# UNITED STATES PATENT AND TRADEMARK OFFICE

APPLICATION NO.	FILING DATE	FIRST NAMED INVENTOR	ATTORNEY DOCKET NO.	CONFIRMATION NO.
10/047,613	01/15/2002	Karl Joachim Ebeling	M&N-IT 213	5759

**Office Action Summary**

## **DETAILED ACTION**

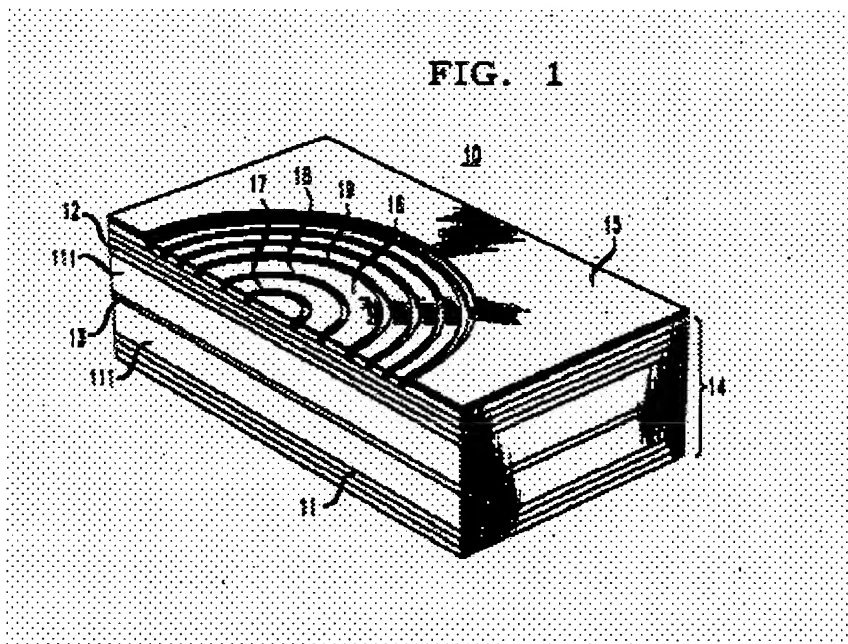
Regarding claim 30,

Figure 1 illustrates a vertical cavity surface-emitting laser (VCSEL) [applicant's vertical resonator] having a top surface (16) [applicant's beam profile shaper] with

multiple trenches (17,18,19...) [applicant's relief structure] (column 2 lines 32-35 and lines 40-44), which affect the reflectivity for selecting the transverse mode [applicant's mode selection] (column 2 lines 54-58).

Regarding claim 31,

Column 2 lines 44-47, discloses the trenches as Fresnel zones [applicant's Fresnel lens].
